T10/04-029r4, SAS-1.1: Close Port Selector Detection Gap

To: T10 Technical Committee  
From: Robert Sheffield (Robert.L.Sheffield@intel.com), Intel Corporation  
Date: July 12, 2004  
Subject: T10/04-029r4, SAS-1.1: Close Port Selector Detection Gap

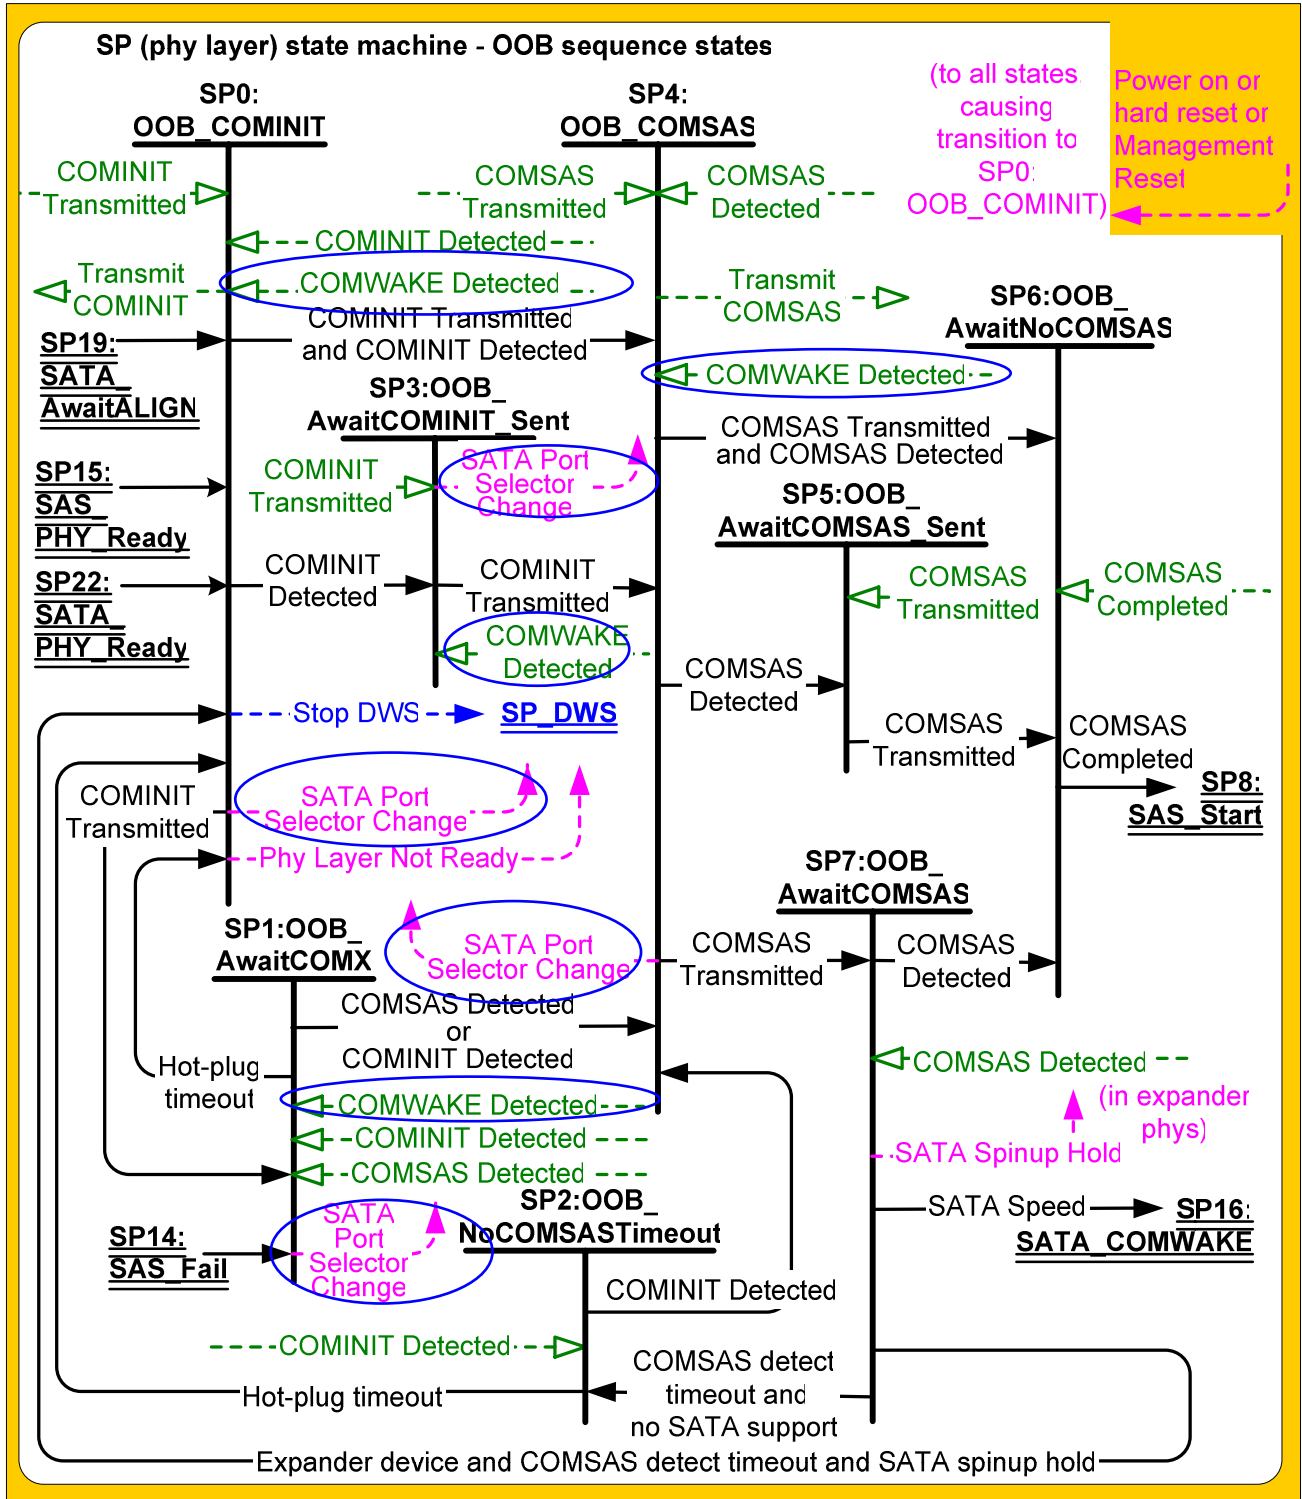
Modify figure 68 in subclause 6.7.3.1 OOB sequence states overview as follows to add SATA Port Selector Change messages sent to the XL State Machine upon receiving the COMINIT Detected message:

Figure 90 — XL (link layer for expander phys) state machine (part 1)

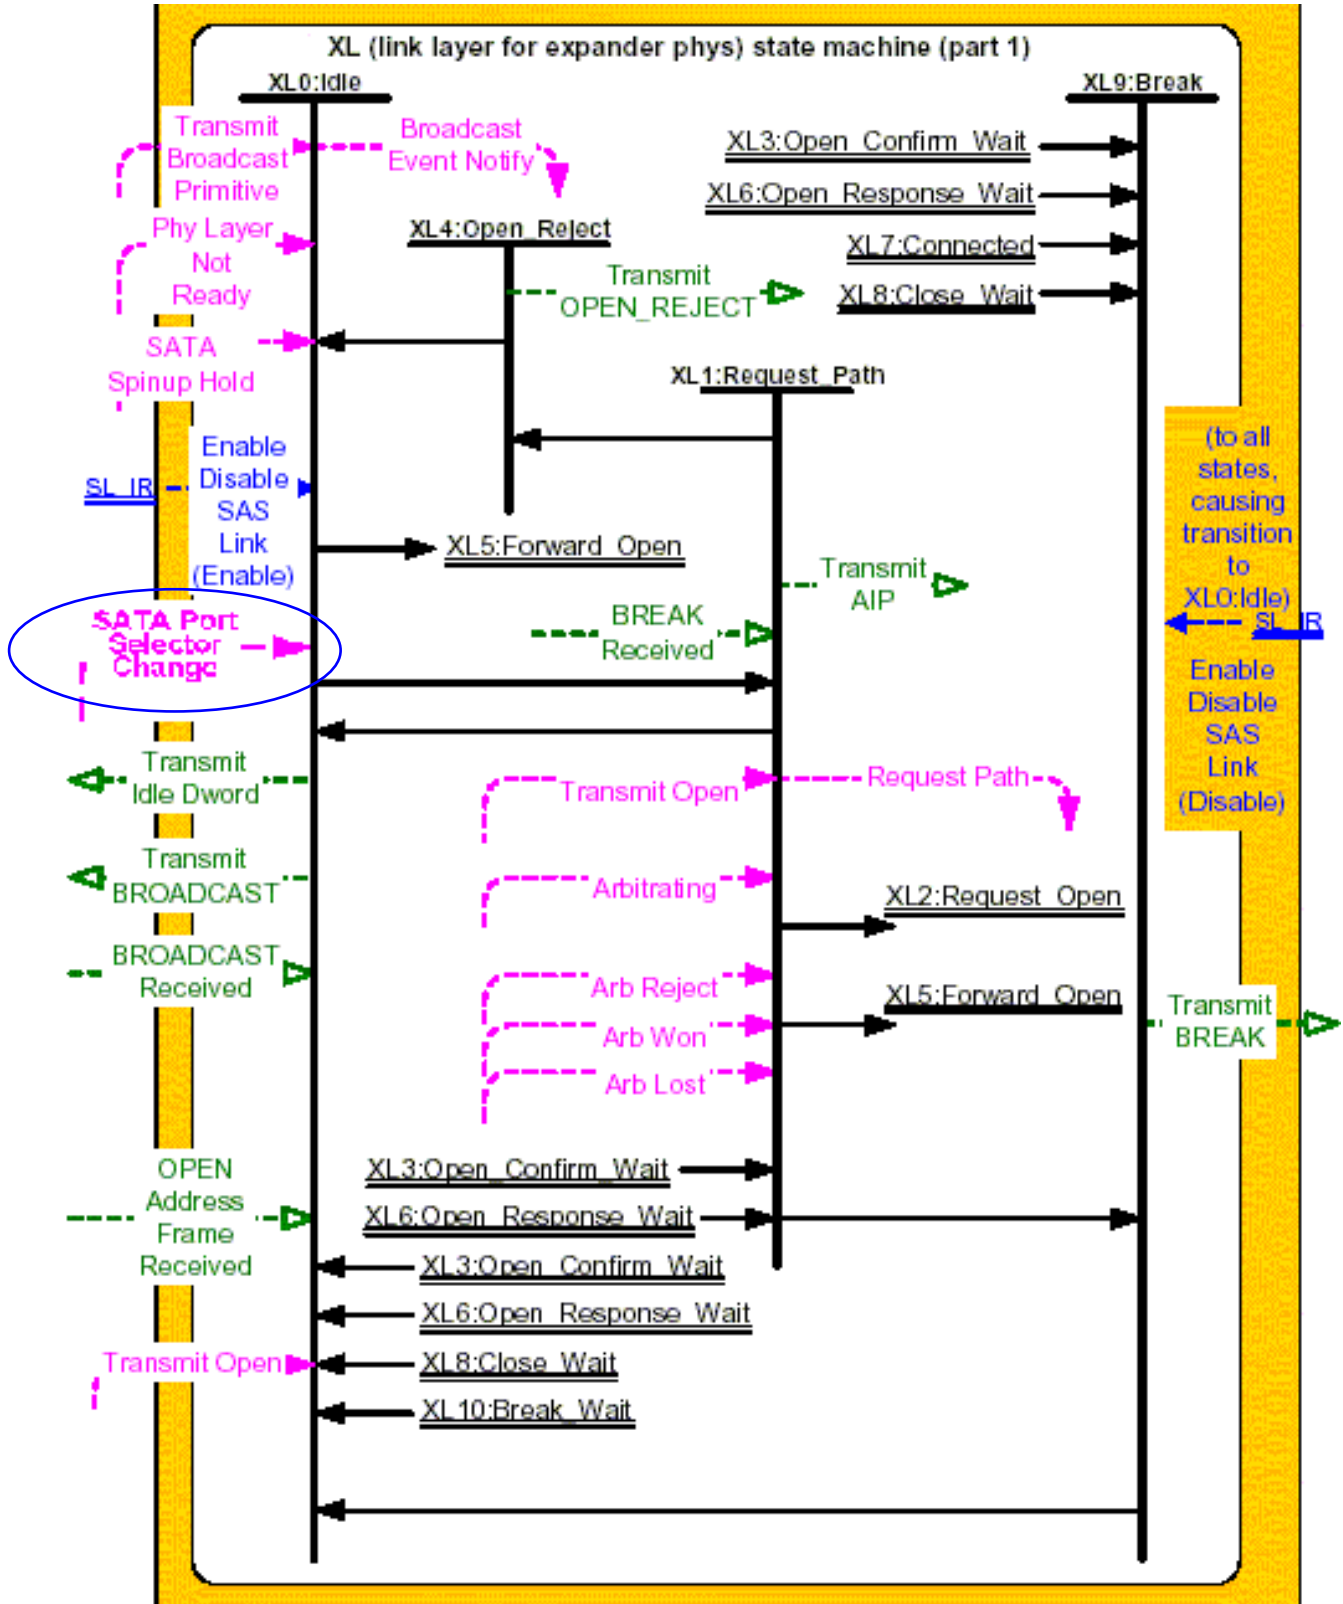
Modify figure 90 in subclause 7.15.1 as follows:

If a SATA Port Selector Change confirmation is received, this state shall send a Broadcast Event Notify (SATA Port Selector Change) request to the BPP.
